**NOTICE OF PUBLIC MEETING  
BUILDING AND ZONING COMMITTEE  
LOCATION: TOWN HALL, 50 COLONY ROAD  
DATE AND TIME: WEDNESDAY, MARCH 20, 2024 AT 5:00 PM**

6. Continued Items:
  - A. #20 Ocean Drive: new two-story residence with outdoor pool. Total under air: 6,834 sf. Total square footage: 9,768 sf. Lot occupancy calculation: 47.97% (50% allowed). Maximum building height: 25' (25' allowed).

- B. #34 Ocean Drive: new two-story residence with outdoor pool. Total under air: 3,795 sf. Total square footage: 4,637 sf. Lot occupancy calculation: 49.29% (50% allowed). Maximum building height: 24'-11¼" (25' allowed).

Jupiter Inlet Colony Plan Review

SP1

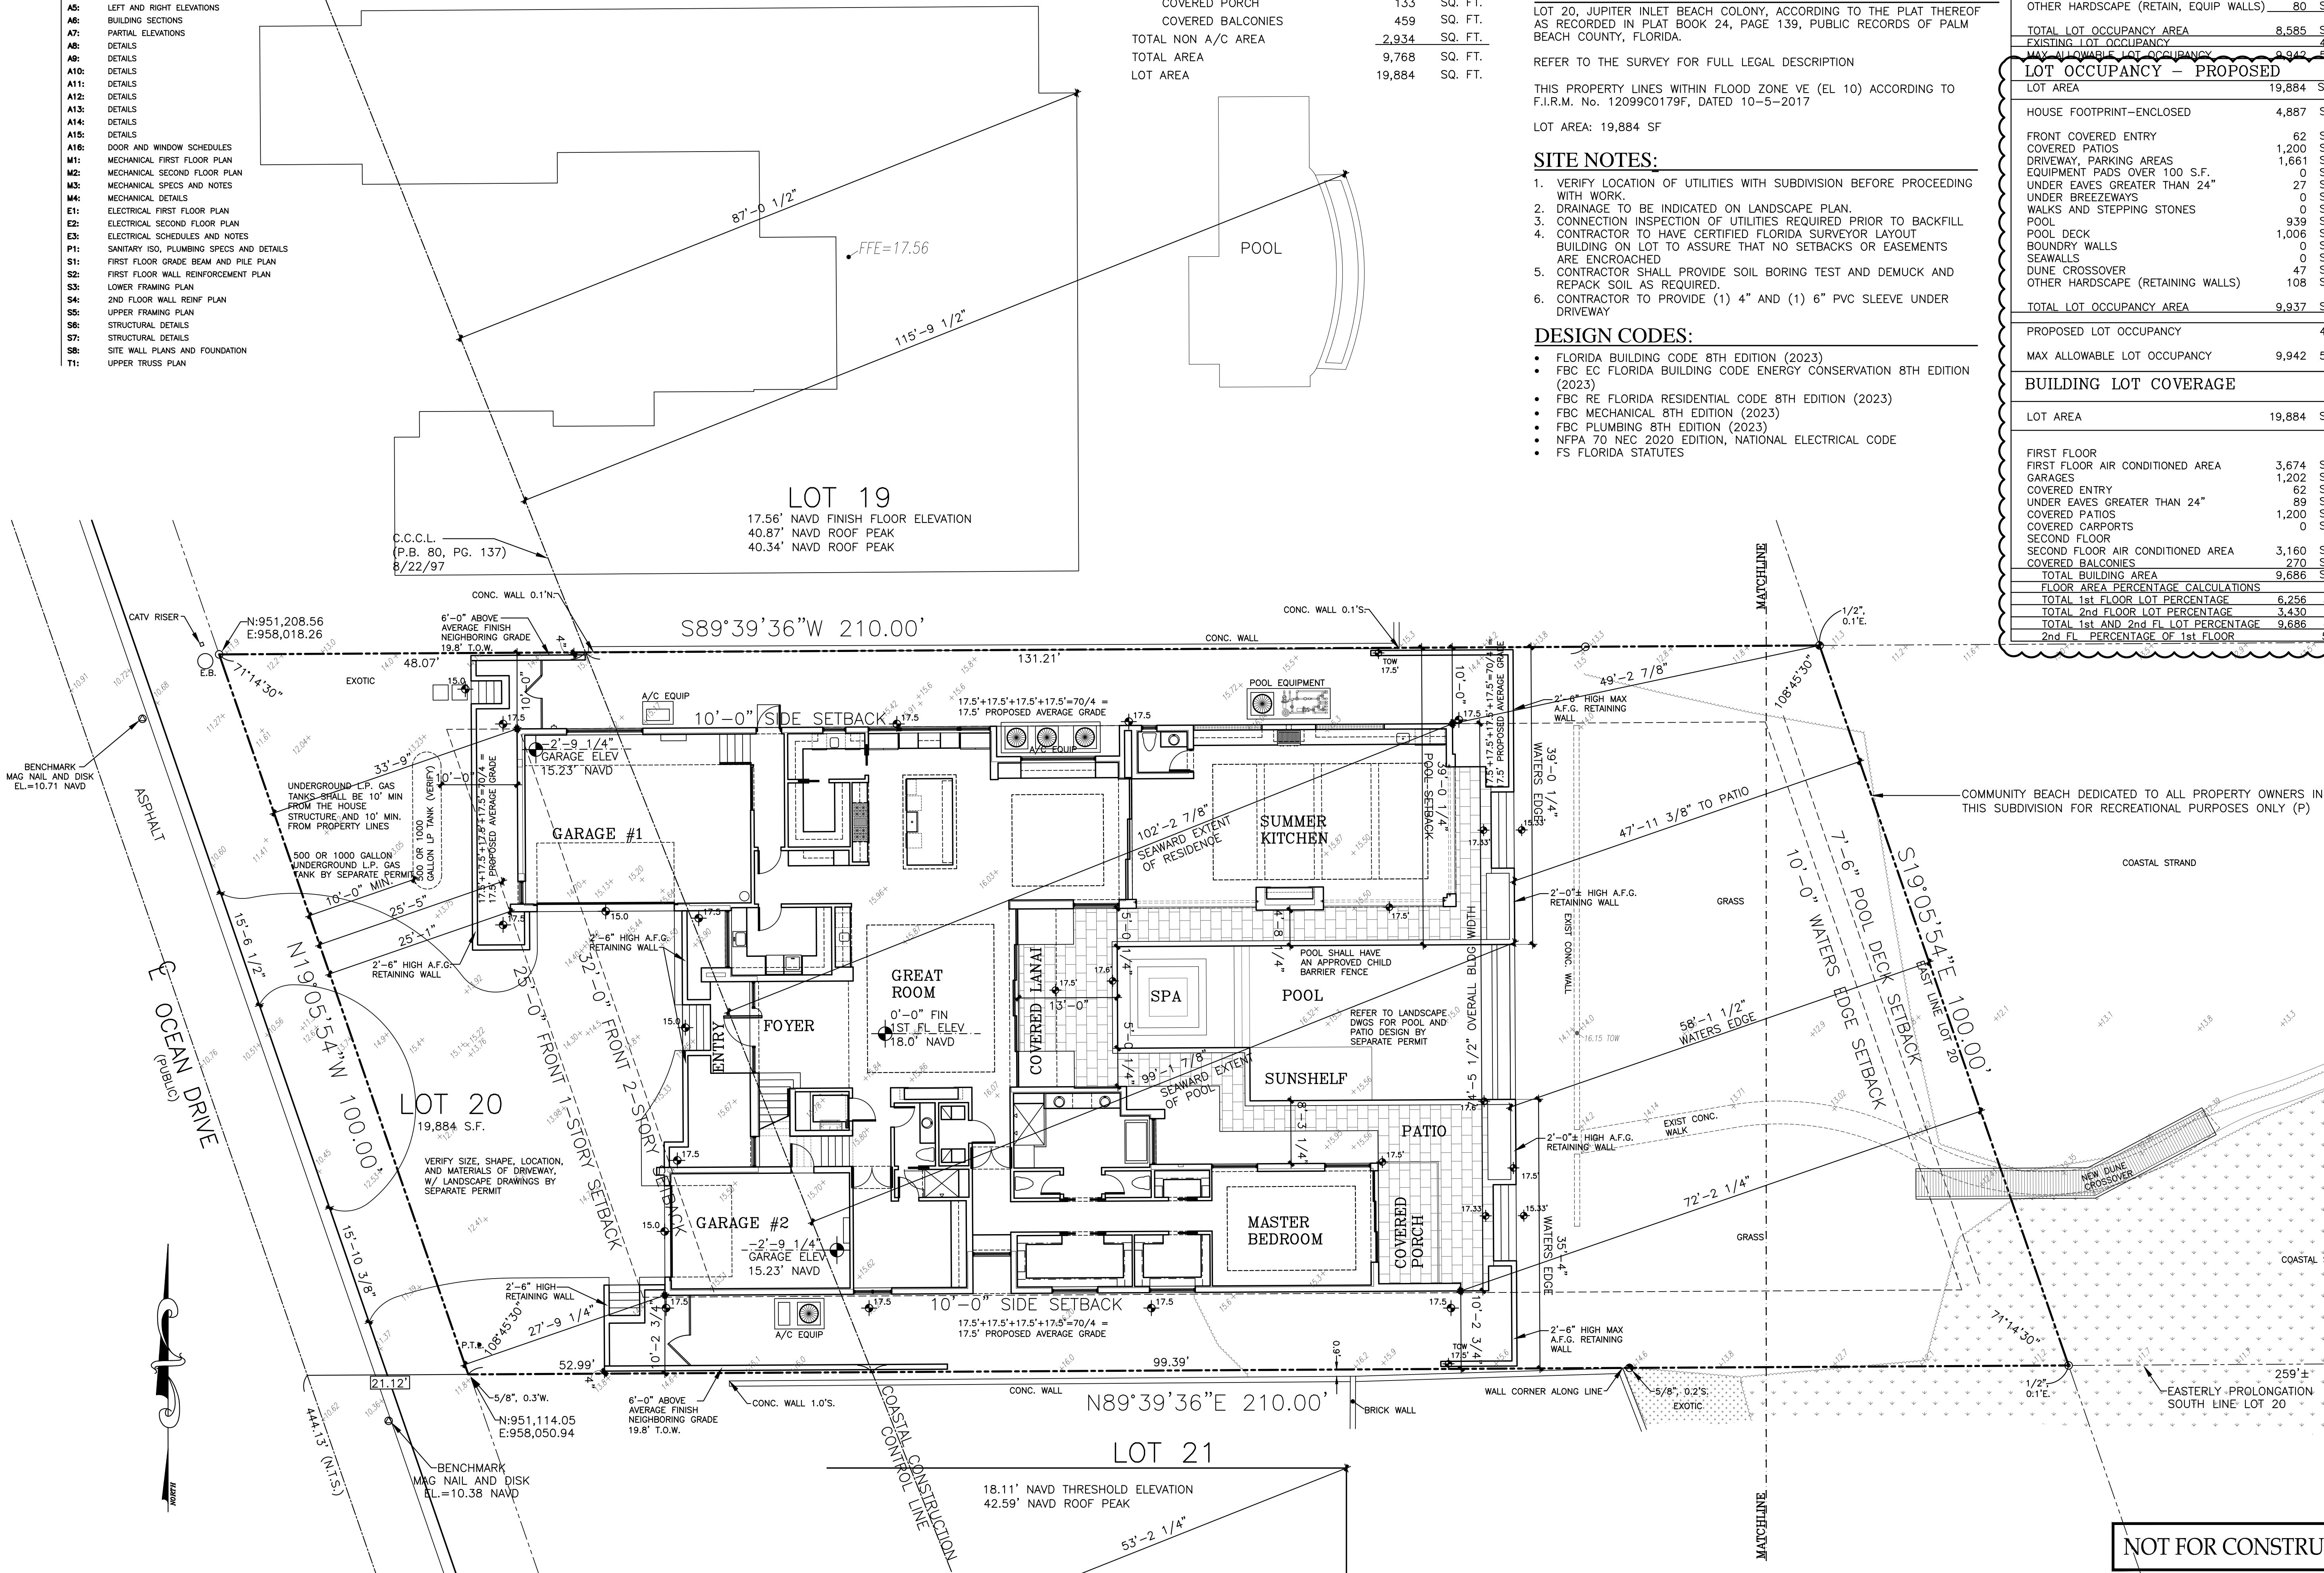
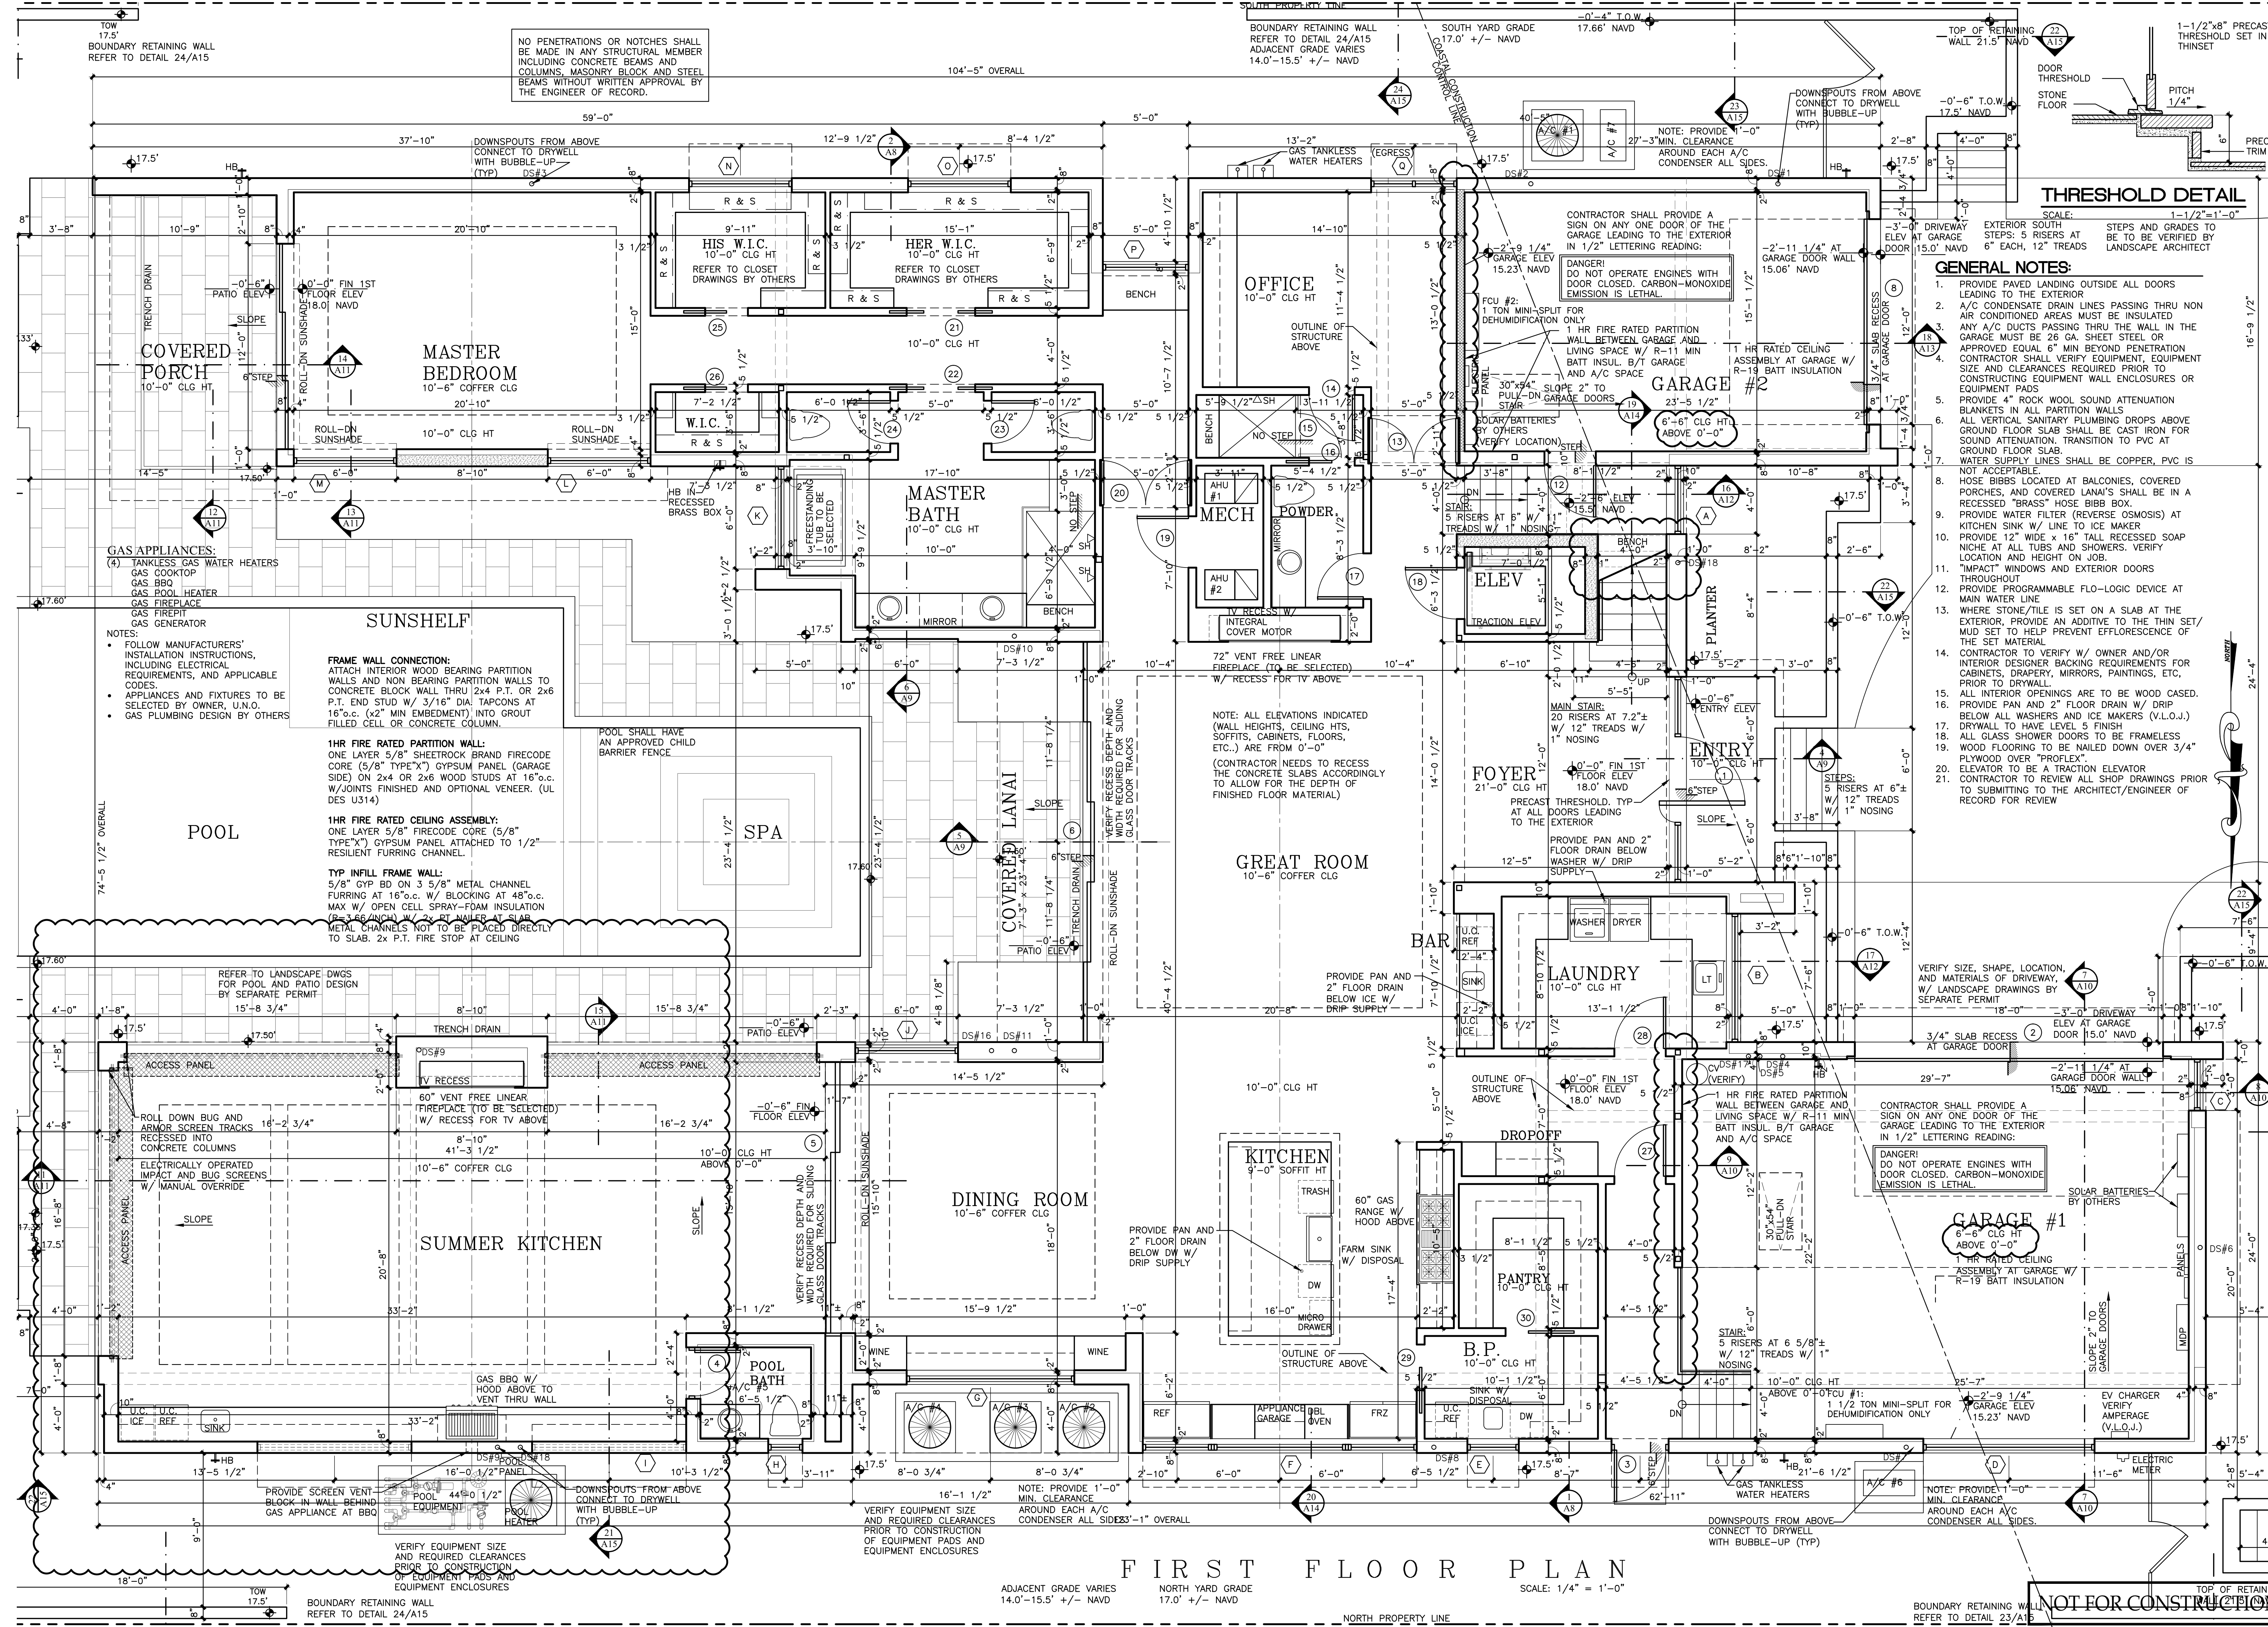
- Revised motorcourt
- Revised Summer Kitchen
- Revised pool patio
- Revise Lot coverage and square footage calculations
